Portland General Electric Company
Trojan Nuclear Plant
71760 Columbia River Hwy.
Rainier, Oregon 97048
(503) 556-3713

CPY-032-96

Response to Request for Additional Information

On May 29, 1996, Mr. Adam Bless sent a Request for Additional Information to Trojan that contained questions about the Trojan Independent Spent Fuel Storage Installation Safety Analysis Report. Attachment I of this letter provides the responses to those questions, with the exception of Questions 25, 40 and 95. Responses to these questions will be provided by August 29, 1996.

Figure 2.5-6 Site Investigation Map

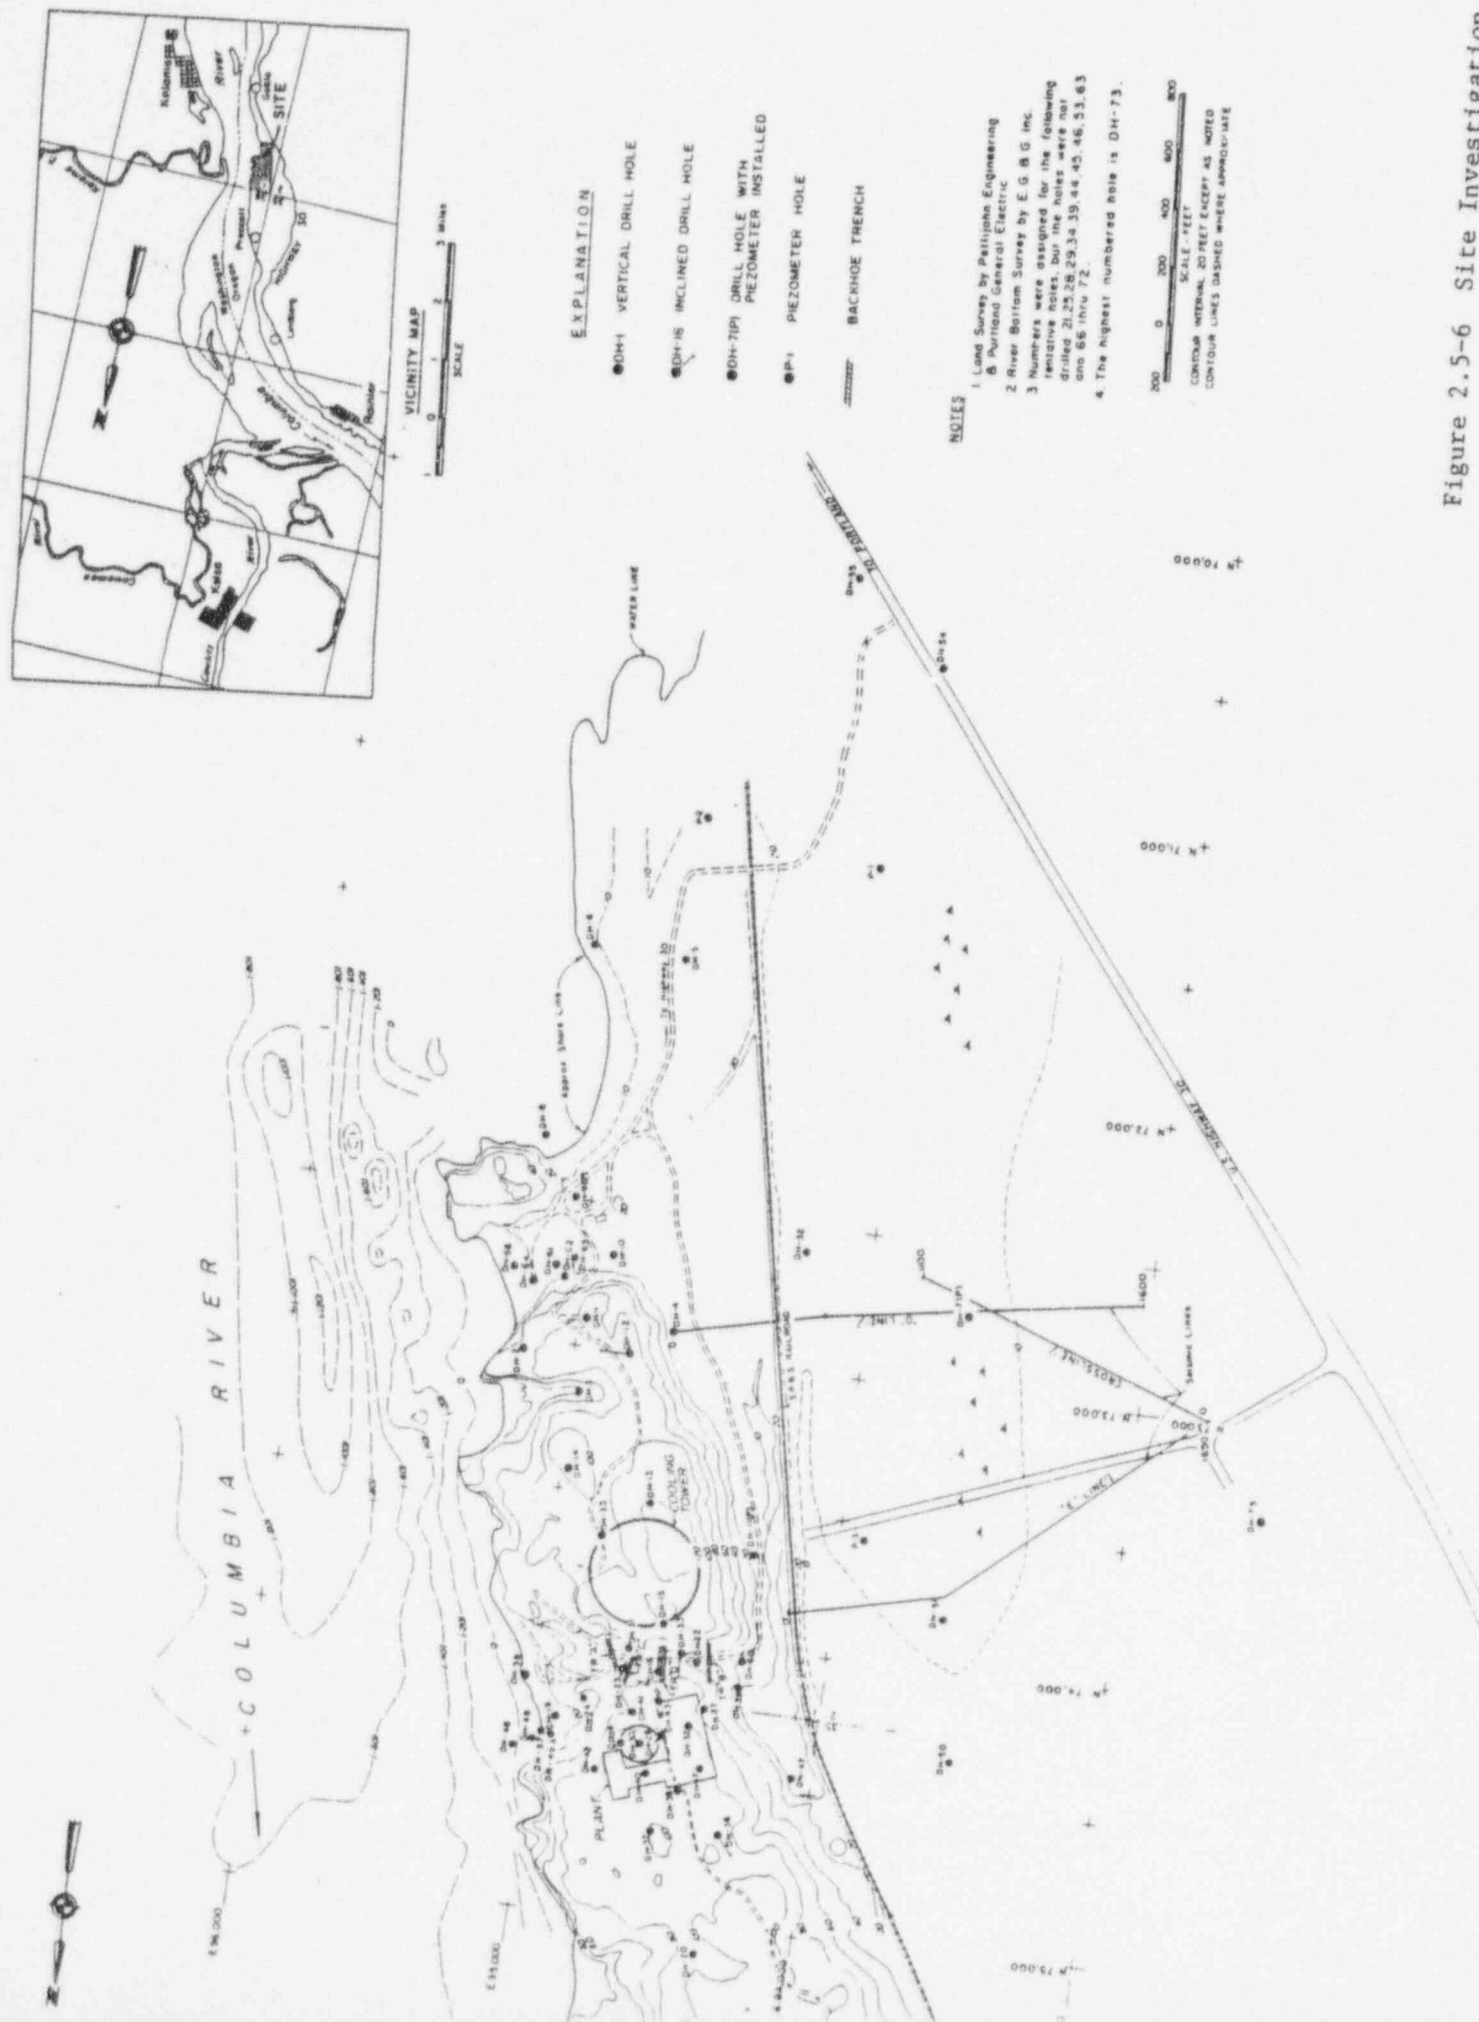
Section 2.6.1.2 refers to drill holes used for geologic mapping. Please provide maps showing the location of these holes, particularly holes DH4,5,7, and 9.

Drill hole locations are shown in Figure 2.5-6 of the Trojan Nuclear Plant Final Safety Analysis Report. A copy of this figure is shown on Attachment II.

Attachment III
Storage Cask Dose Models (proprietary information deleted)

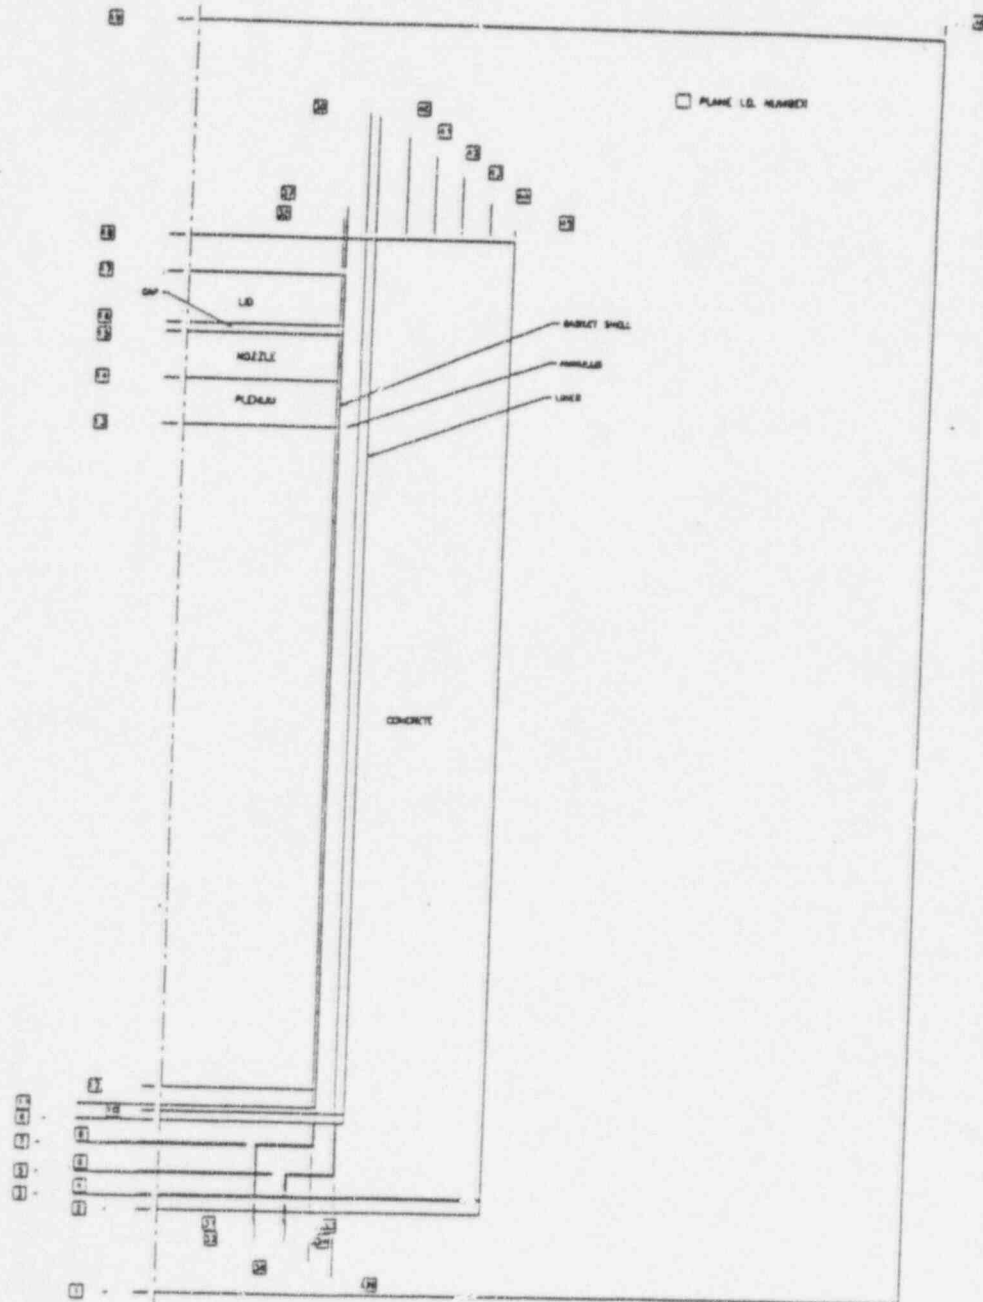
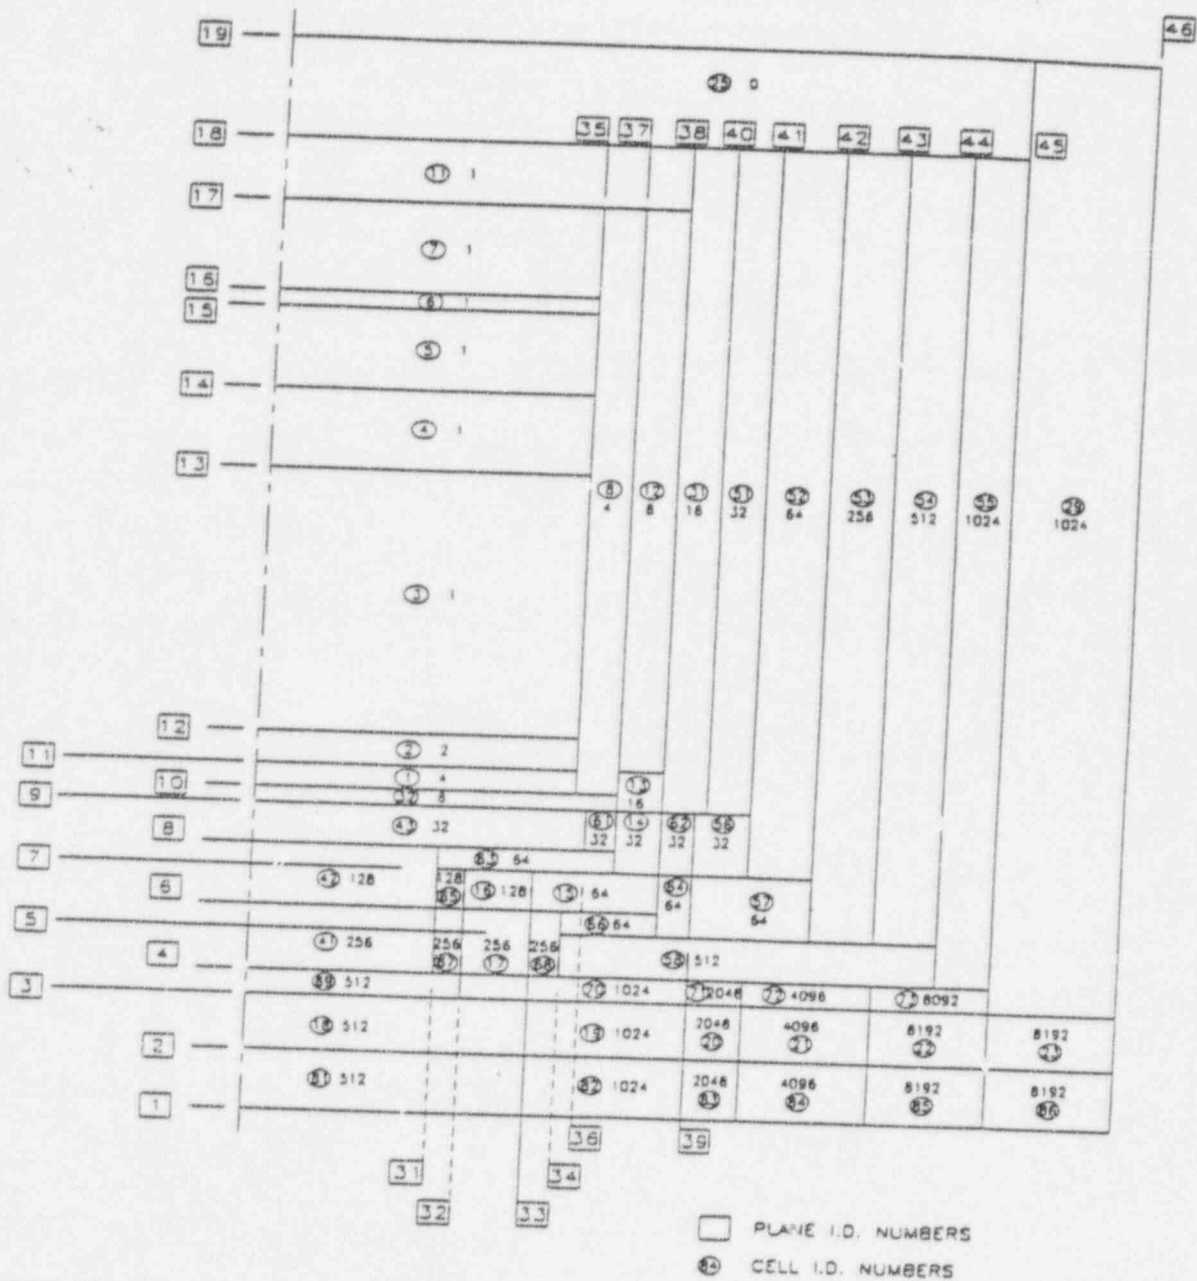
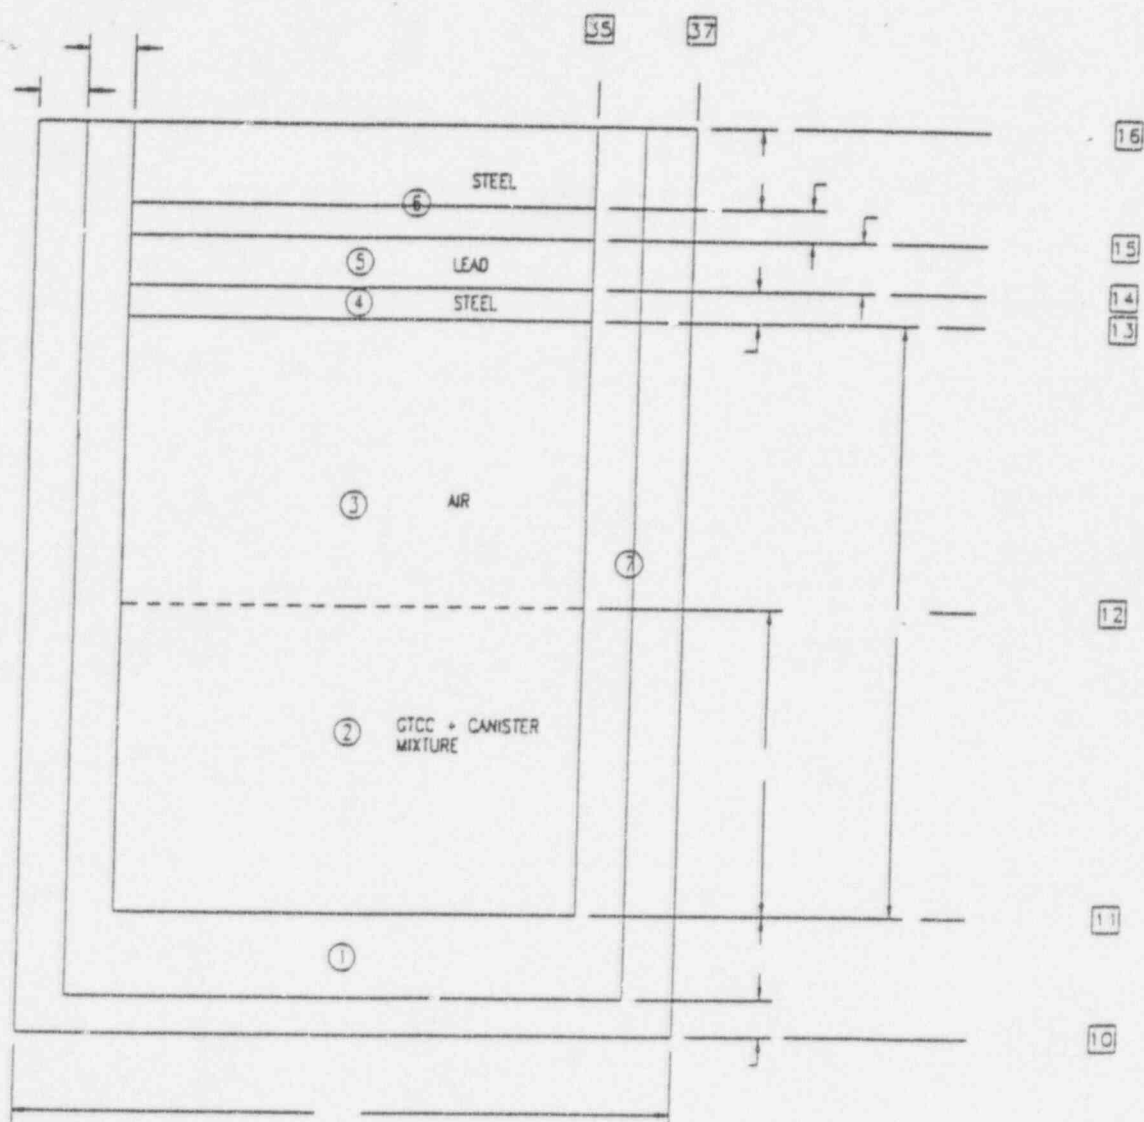
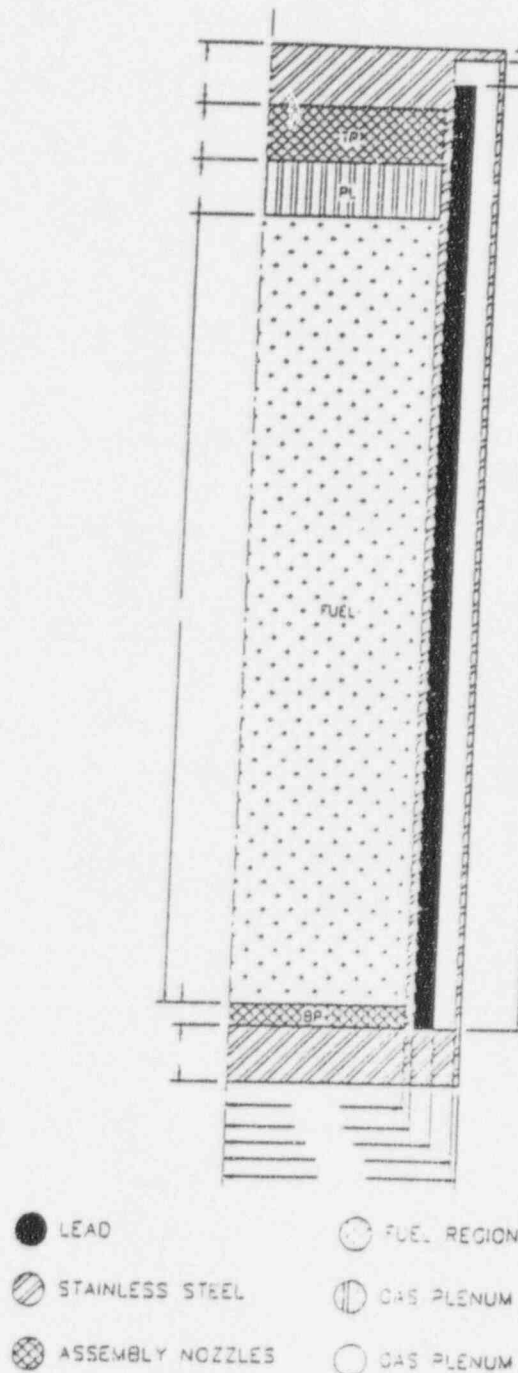
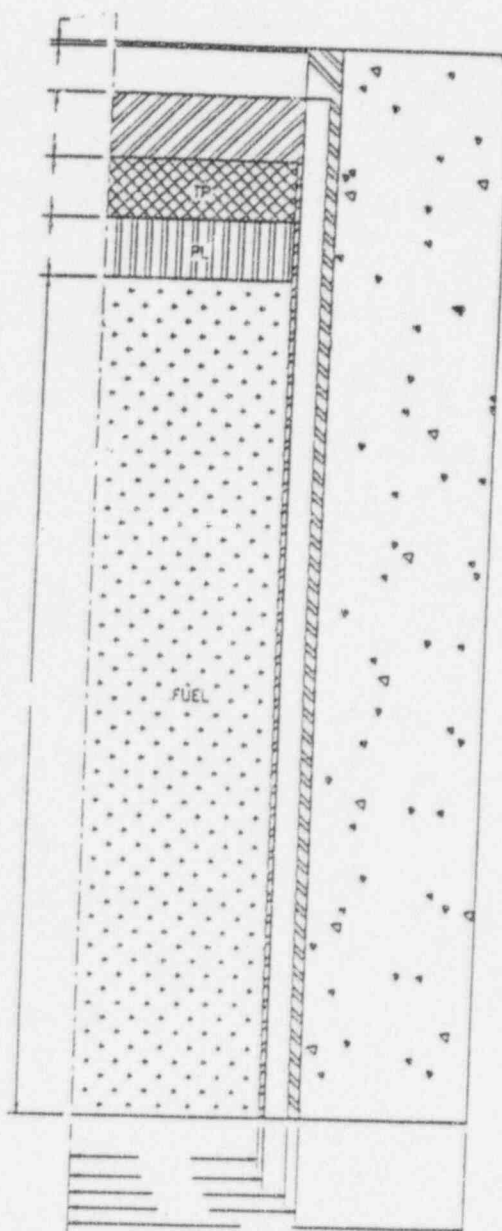
Section 3.3.5.3, p. 3-21, states that "the estimated working dose rates for the PWR cask (maximum fuel burnup) and GTCC cask are 10 mrem/hr and 31 mrem/hr, respectively, and the dose at 100 meters (based on a 2000 hour occupancy) is 24 mrem/yr as described in Chapter 7." Please provide the assumptions and calculations for these results. Also, if the estimate is 24 mrem/yr at 100 meters, what is the estimate at the "Restricted Area" fence, which is less than 100 meters from the ISFSI pad?

The estimated working dose rates, which are provided in ISFSI SAR Tables 7.4-1 and 7.4-2 and Figures 7.3-9 through 7.3-12, were calculated using various methods and assumptions because the dose rates are a combination of gamma radiation, neutron radiation (for fuel only), and scattered radiation, and the configuration of the cask is not uniform (e.g., air inlets and air outlets). The methodology and assumptions used to calculate the estimated dose rates for the casks are described in detail in ISFSI SAR section 7.3.2.2. The one-dimensional models used to calculate the direct gamma dose rates are shown in ISFSI SAR Figures 7.3-1 through 7.3-8. The model for calculating the air inlet dose rate and the 2-dimensional models used for calculating neutron dose rates are attached. (Attachment III)
